Office Action Summary

10/626,592

MATSUNAGA ET AL.

DETAILED ACTION

FIG. 1

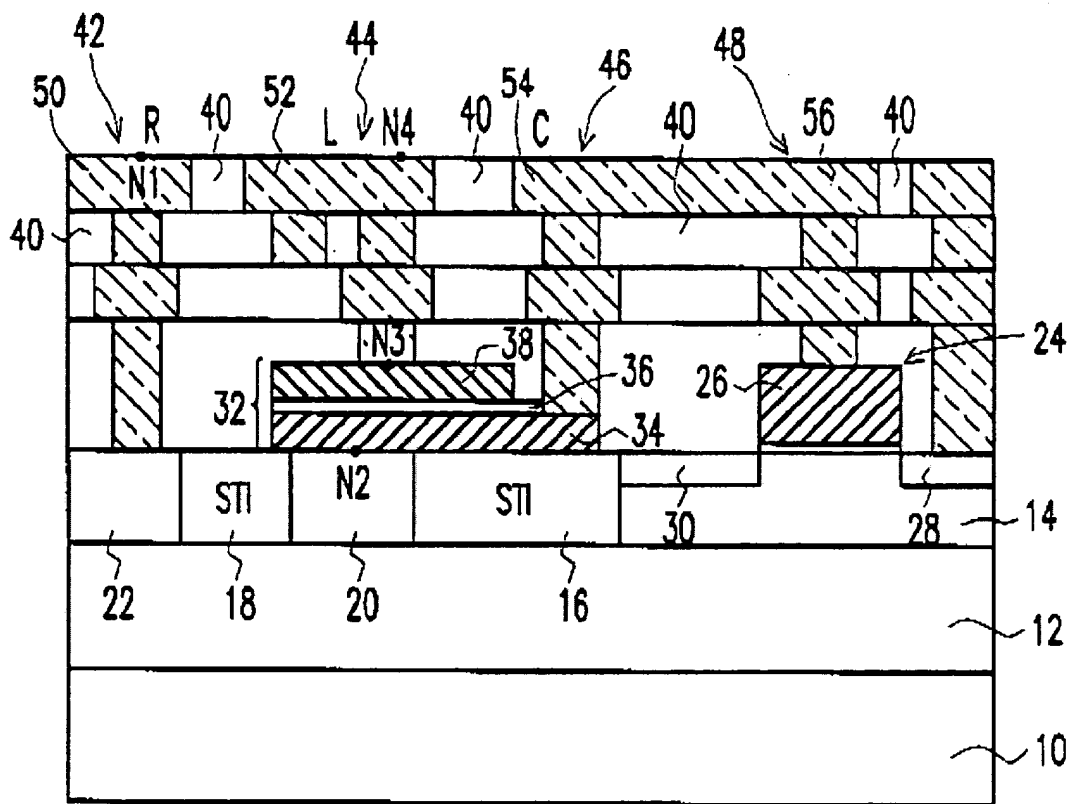
1. Claims 1, 3 and 7 are rejected under 35 U.S.C. 102(e) as being anticipated by Yeh et al. (U.S. Patent No. 6,294,834). With regard to Claim 1, Yeh discloses on figure 1 a semiconductor device, comprising: a multilayer wiring structure including a plurality of wiring layers formed on a substrate (10), a capacitor (32) arranged in a predetermined wiring layer in the multilayer wiring structure and including a lower electrode (34), a dielectric film (36), and an upper electrode (38), a first via formed in the predetermined wiring layer and connected to a top surface of the upper electrode (38) of the capacitor, and a second via formed in an overlying wiring layer stacked on the predetermined wiring layer, the second via formed on the first via and the second via being connected to a wiring formed in the overlying wiring layer. For the purpose of further illustrating the teachings of Yeh, figure 1 is reproduced herein.

With regard to Claim 3, Yeh discloses that the predetermined wiring layer has a third via formed on the lower electrode (34) and a wiring connected the third via and buried in a surface of the predetermined wiring layer. See figure 1.

With regard to Claim 7, Yeh discloses that the overlying wiring layer has a wiring connected to a top of the second via and buried in a surface of the overlying wiring layer. See figure 1.
